PREPARED FOR THE PLAN COMMISSION

Project Address: 5535 University Avenue (District 19 – Ald. Furman)
Application Type: Demolition Permit and Conditional Use
Legistar File ID #: [66120](#)
Prepared By: Chris Wells, Planning Division
Report Includes Comments from other City Agencies, as noted
Reviewed By: Heather Stouder, AICP, Planning Division Director

Summary

Image 1: Section Looking Eastward

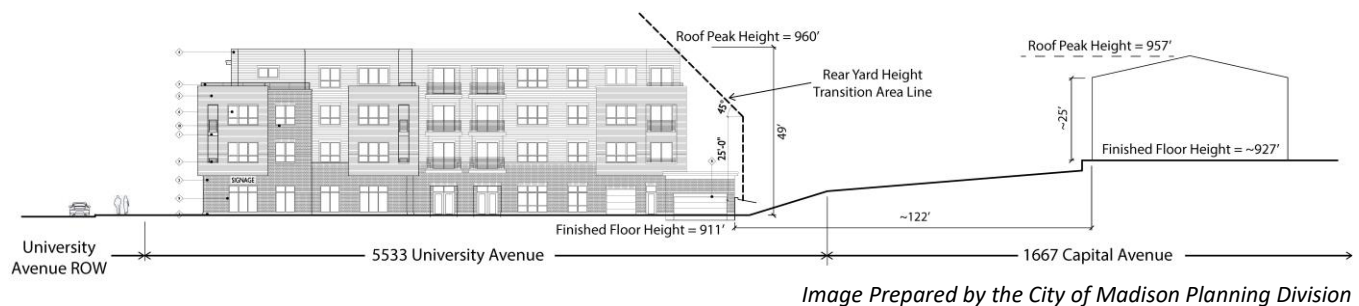
Looking at Image 1 below, one can see the upper right corner of the building (i.e. the southeasterly corner of the building’s fourth floor) barely extending into the transition area (which is indicated by the angled dashed line). (Note: this infringement has not changed from the previously approved plans). While such a restriction on height transitions is most applicable, and valuable, in infill situations when, for example, a multi-story building is proposed on a block of small and/or narrow lots, for the 5535 University Avenue case, Planning Staff anticipate that that this specific encroachment will not result in noticeably different impacts than what would be allowed without the requested conditional use. This is due to the fact that the adjacent two-story residential building is 122 feet away, and also due to the significant grade change between properties. The level of the ground floor of the neighboring building is roughly 16 feet above that of the subject building.
